ADDENDUM
NO. 2

April 20, 2021

HANOVER CENTRAL HIGH SCHOOL ADDITIONS AND RENOVATIONS
Cedar Lake, IN 46303

Addendum Two (AD.02) to the drawings and specifications prepared by Gibraltar Design and The Skillman Corporation for **Hanover High School Addition and Renovations** for Hanover Community School Corporation, Cedar Lake, Indiana.

SHEET C-1.1

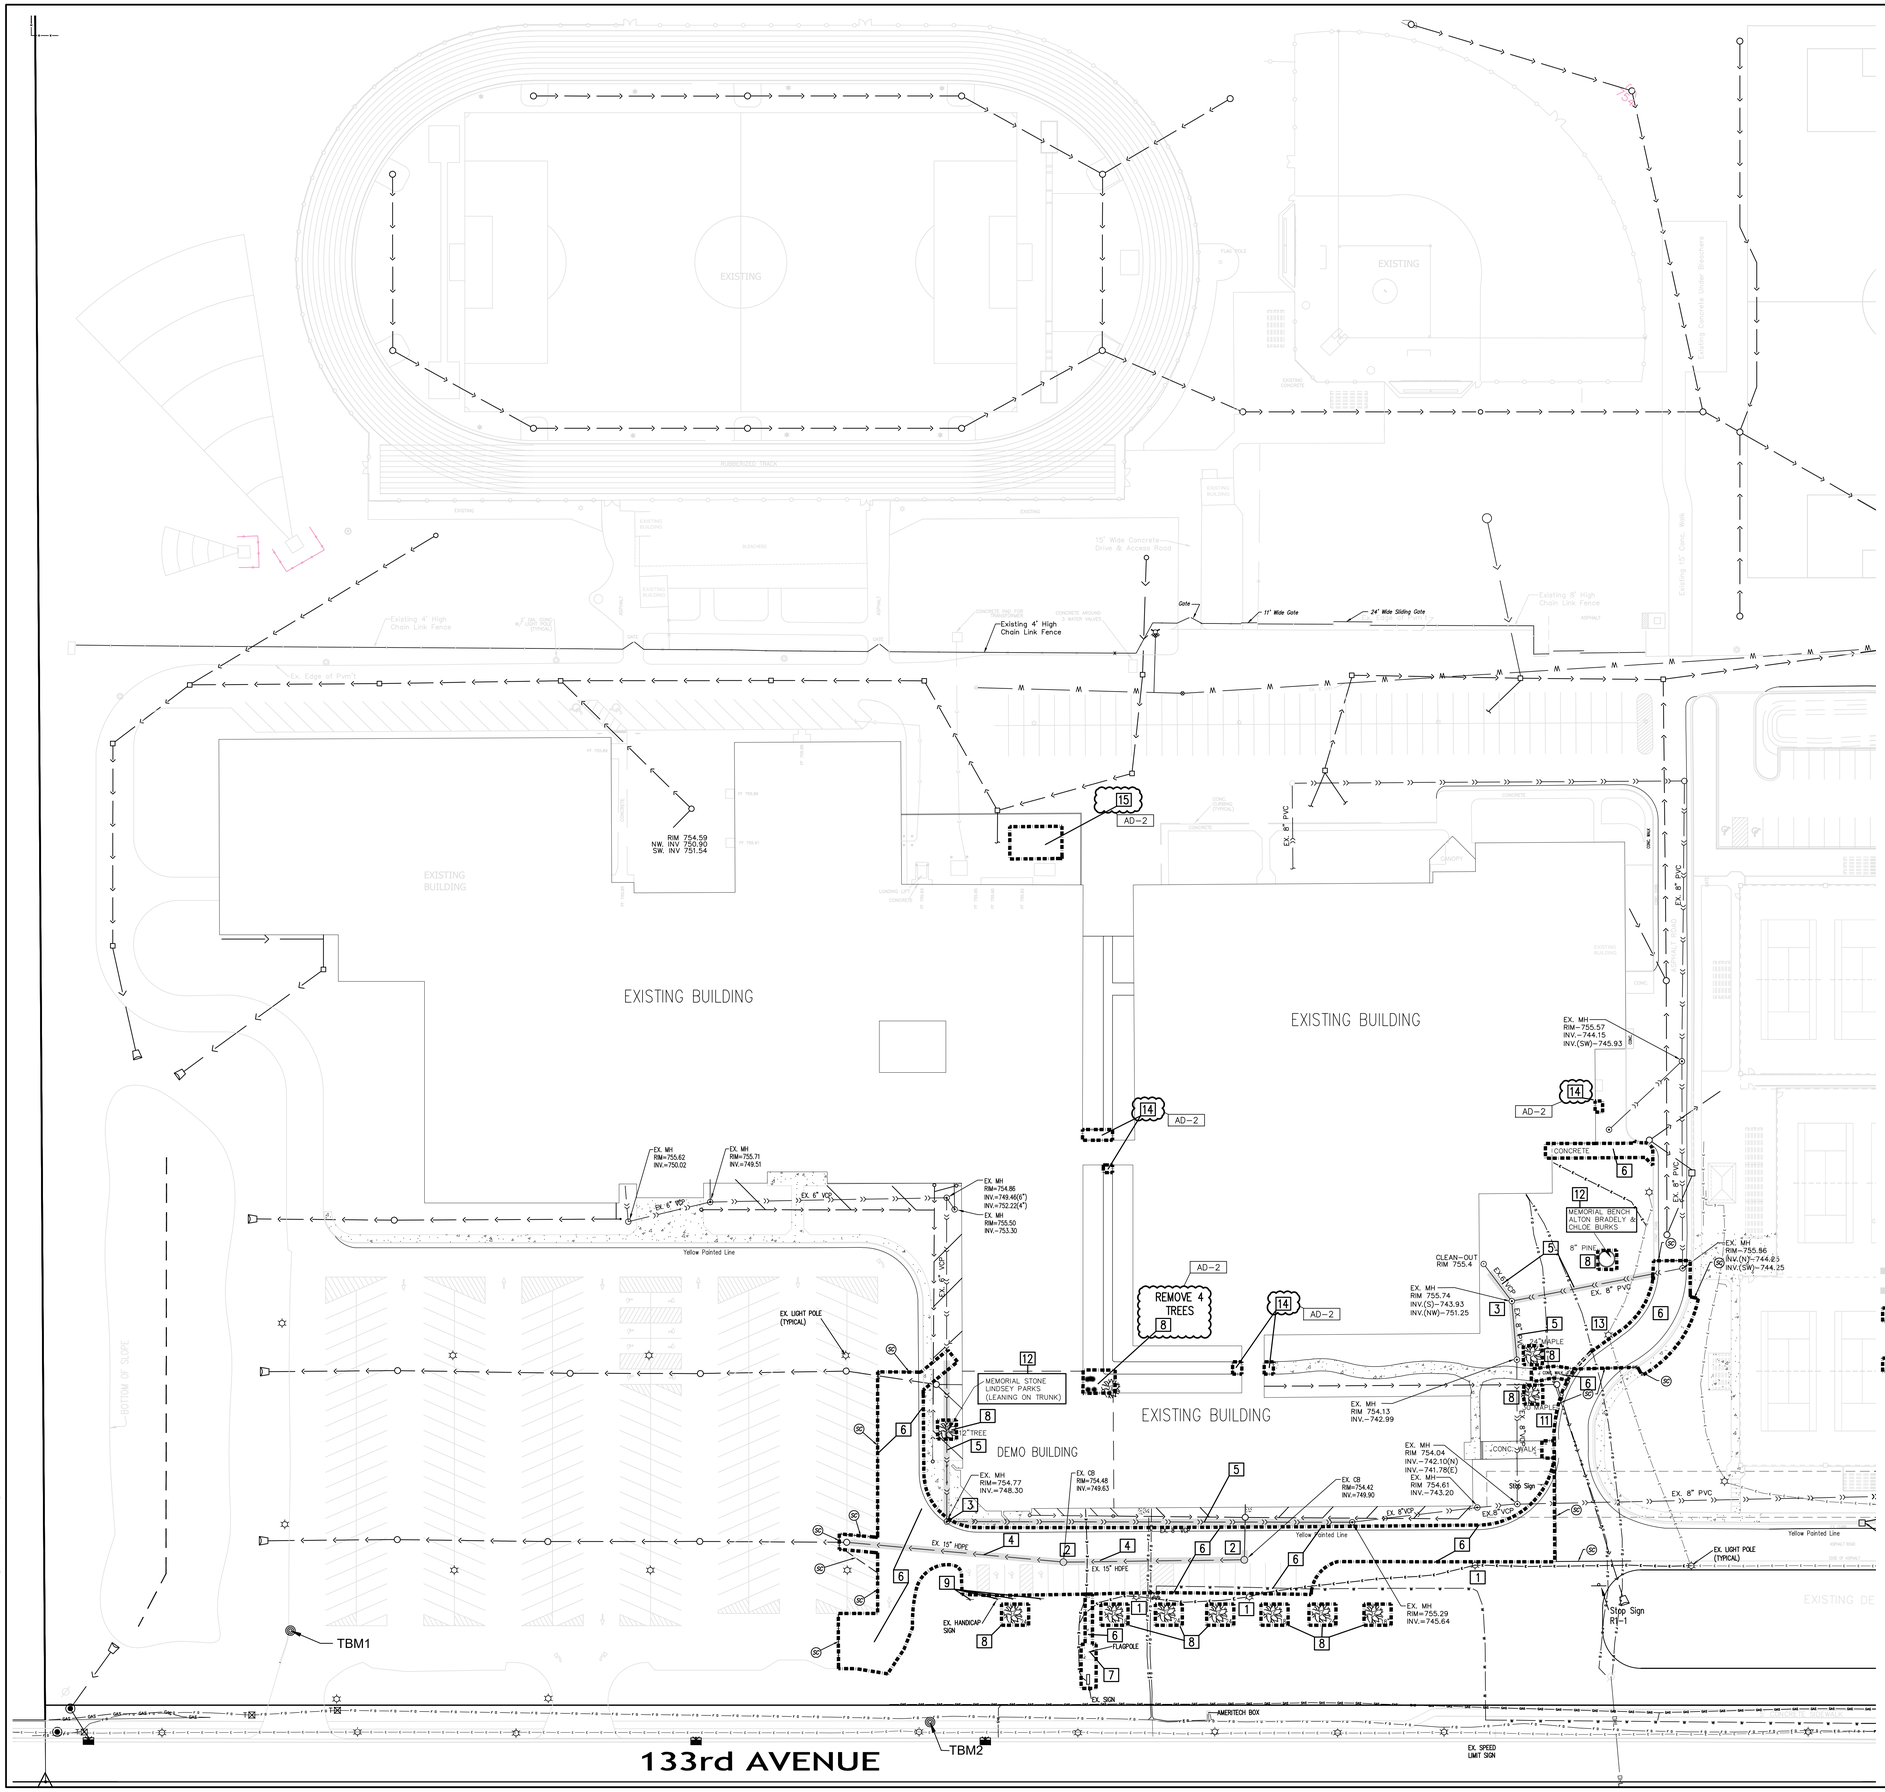
10. Sheet C-1.1

A. Refer to revised full-size drawing, included in this Addendum, for the following revisions.

1 FRAMING PLAN - UNIT A
1/8" = 1'-0"

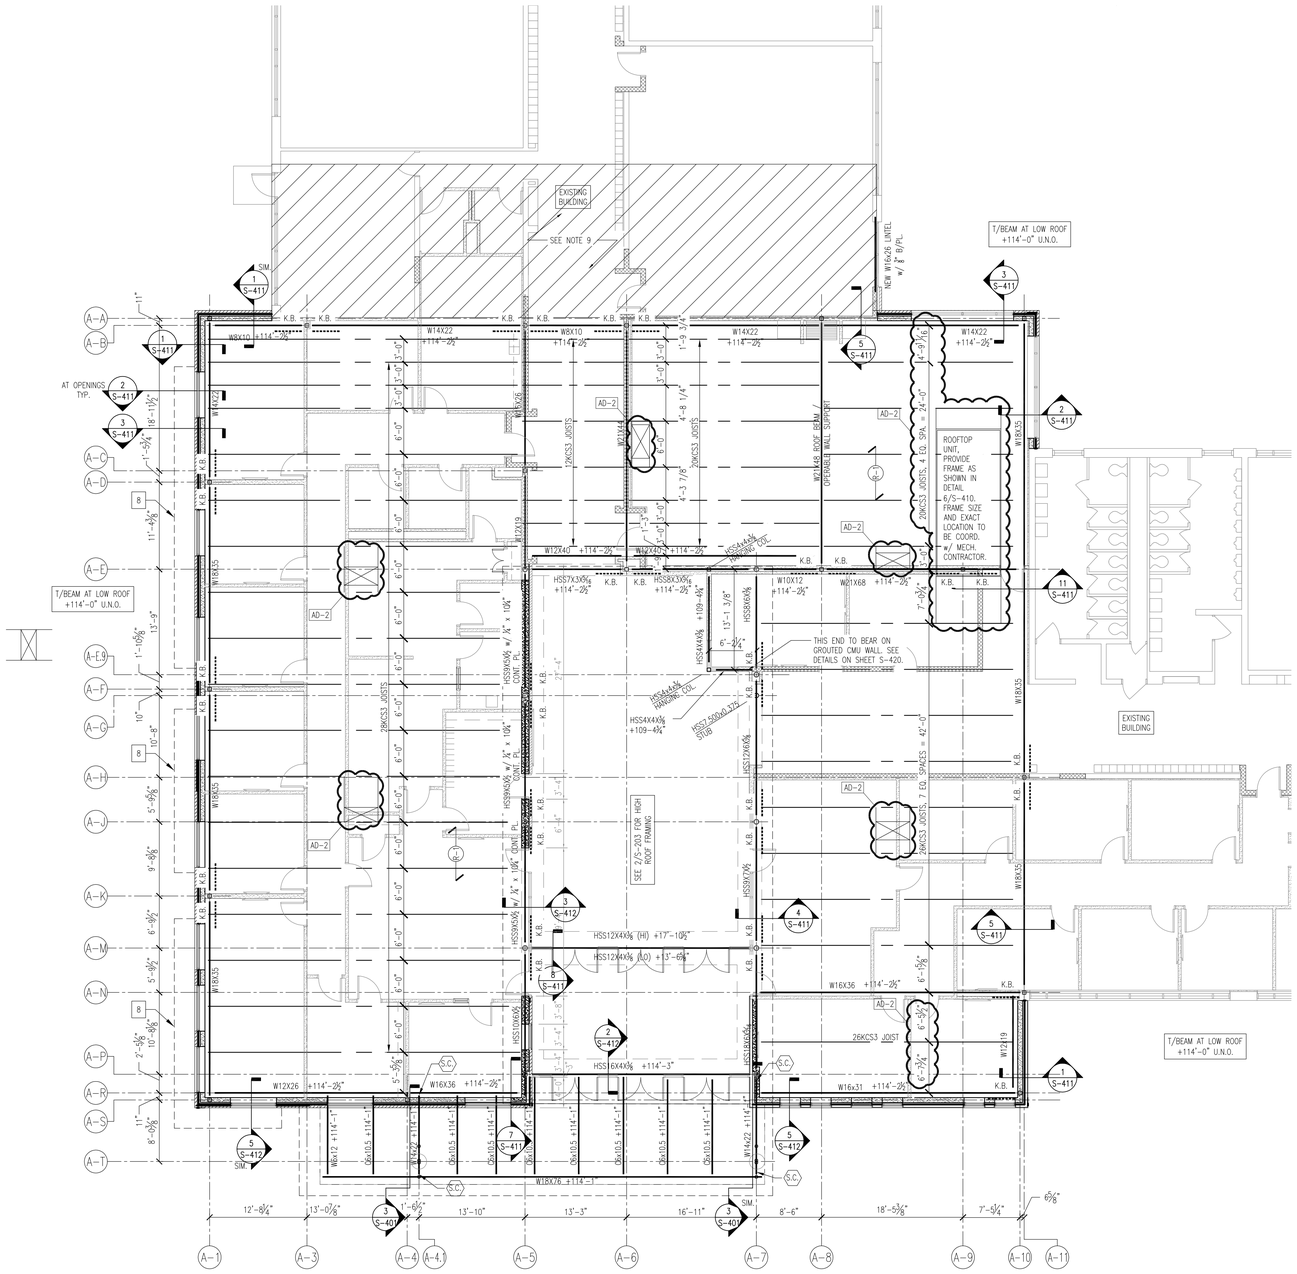
19. Sheet S-203

A. Refer to revised full-size drawing, included in this Addendum, for the following revisions.

1. Showed approximate locations of roof drain frames on structural plan.
    a. Roof Drain frame symbol and description was added to framing plan notes.
2. Roof top unit approximate location is shown on roof plan.
    a. Roof joists supporting the roof top unit have changed size to account for the load.
3. Joist spacing dimensions were added to the low roof framing plan.

1 FRAMING PLAN - UNIT B

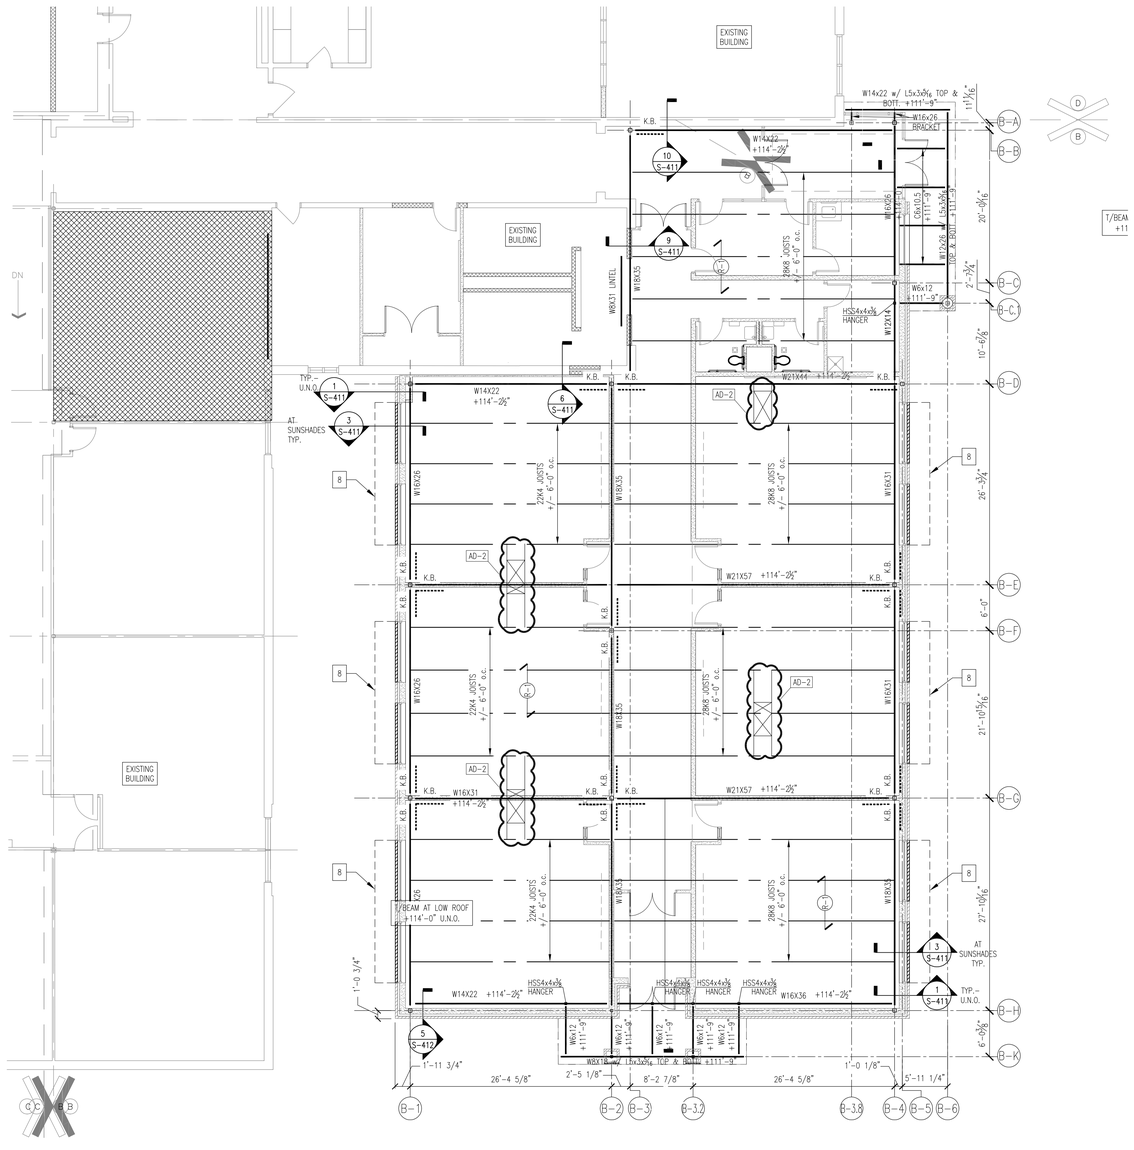
20. Sheet S-204

A. Refer to revised full-size drawing, included in this Addendum, for the following revisions.

1. Showed approximate locations of roof drain frames on structural plan.

a. Roof Drain frame symbol and description was added to framing plan notes.

UNIT "A" MECHANICAL VENTILATION FIRST FLOOR PLAN

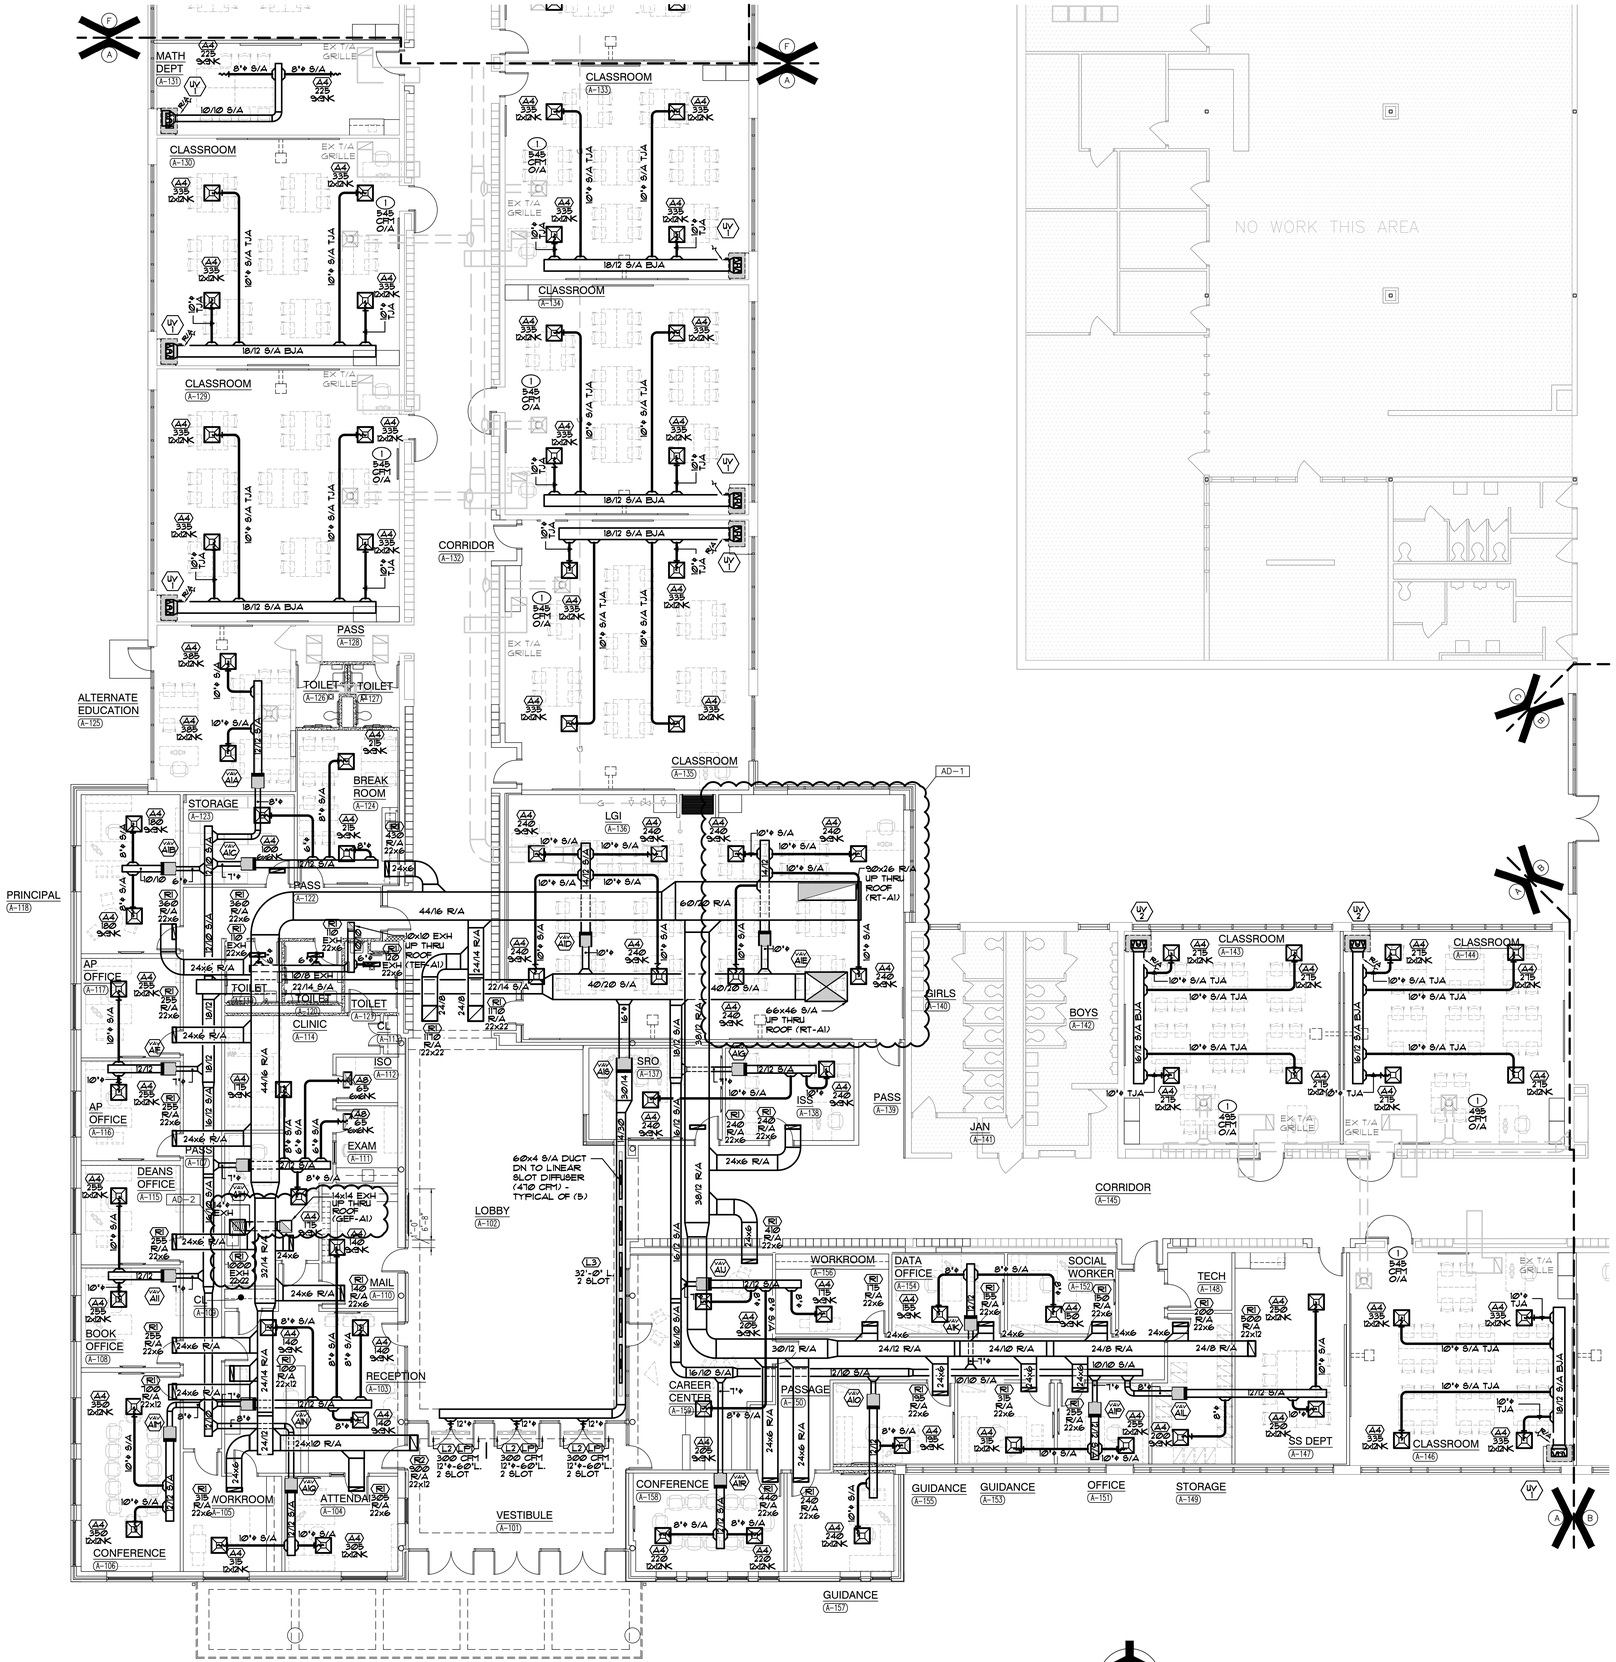
35. Sheet MV101

A. Refer to revised full-size drawing, included in this Addendum, for the following revisions:

1. Added exhaust ductwork for GEF-A1.

UNIT "C" MECHANICAL VENTILATION FIRST FLOOR PLAN
SCALE: 1/8" = 1'-0"

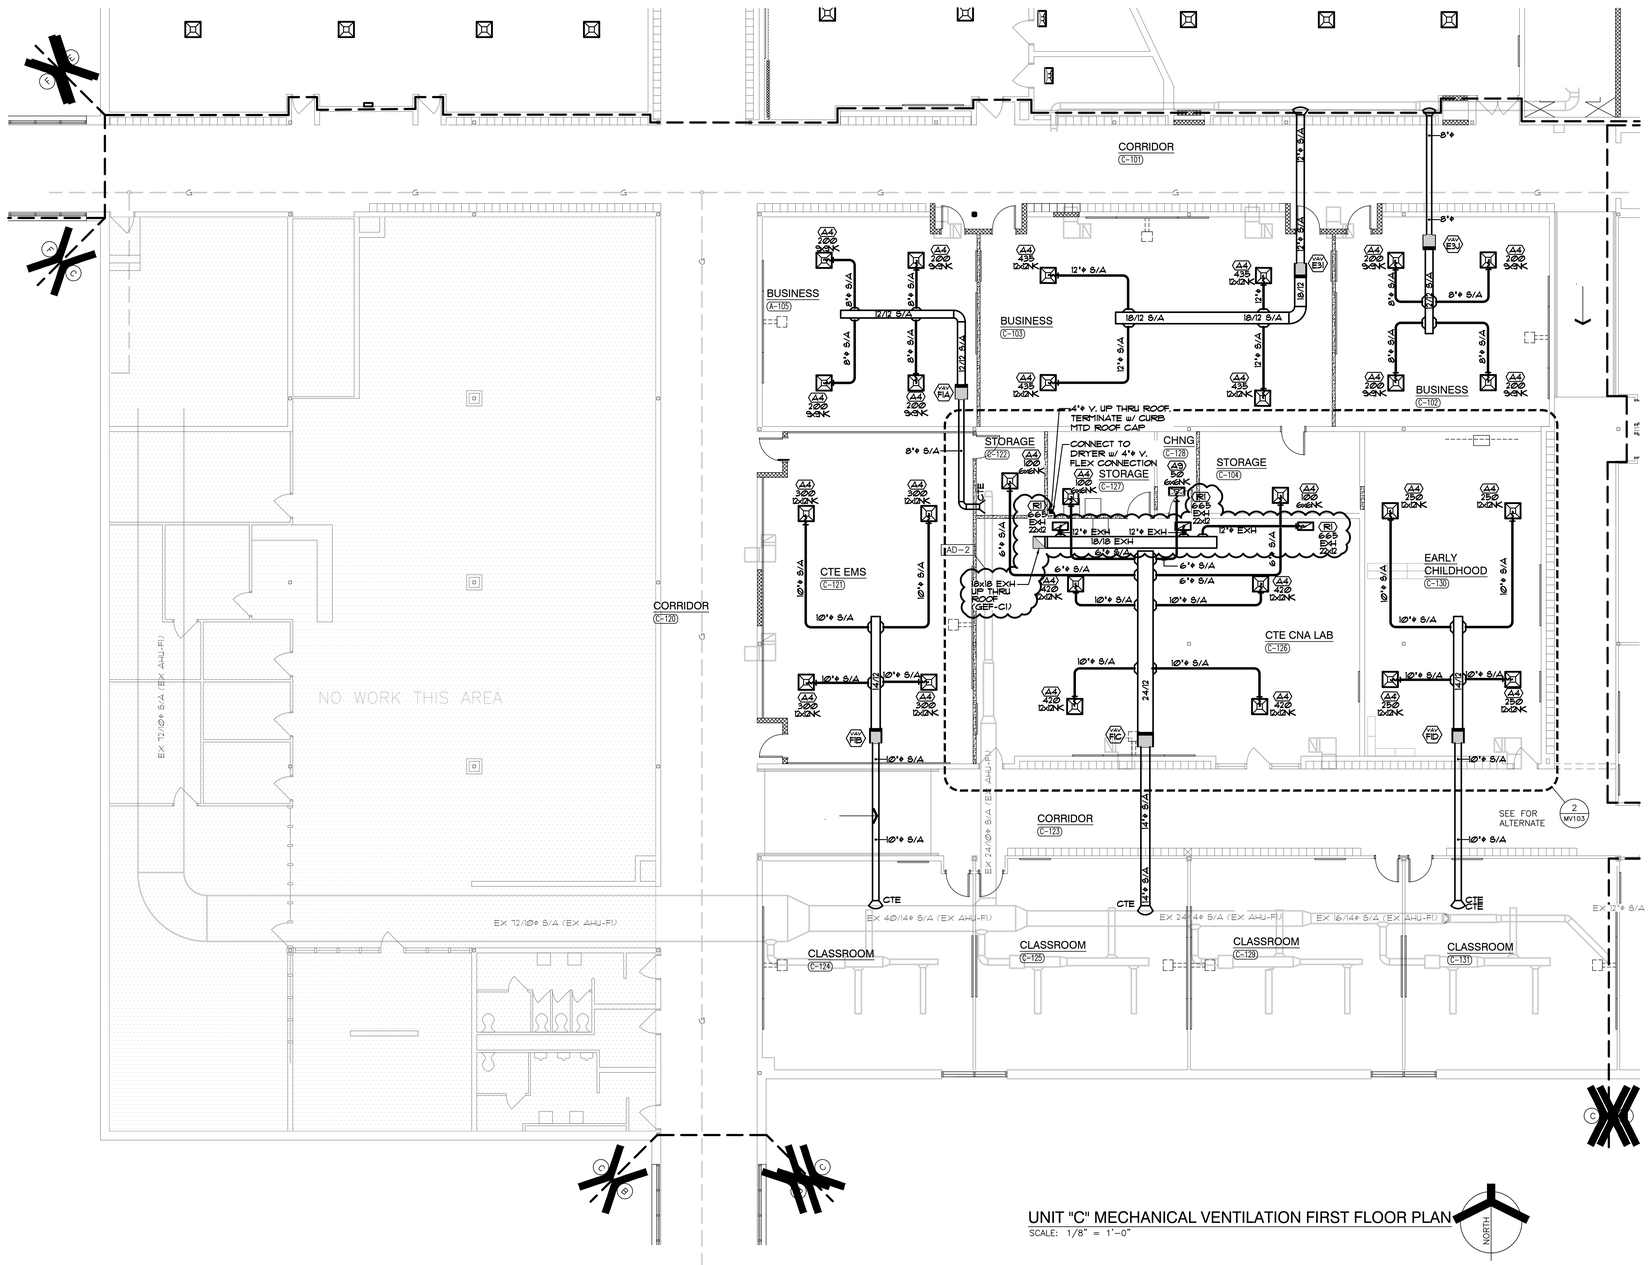
36. Sheet MV103

A. Refer to revised full-size drawing, included in this Addendum, for the following revisions:

1. Added tags for GEF-C1 ductwork
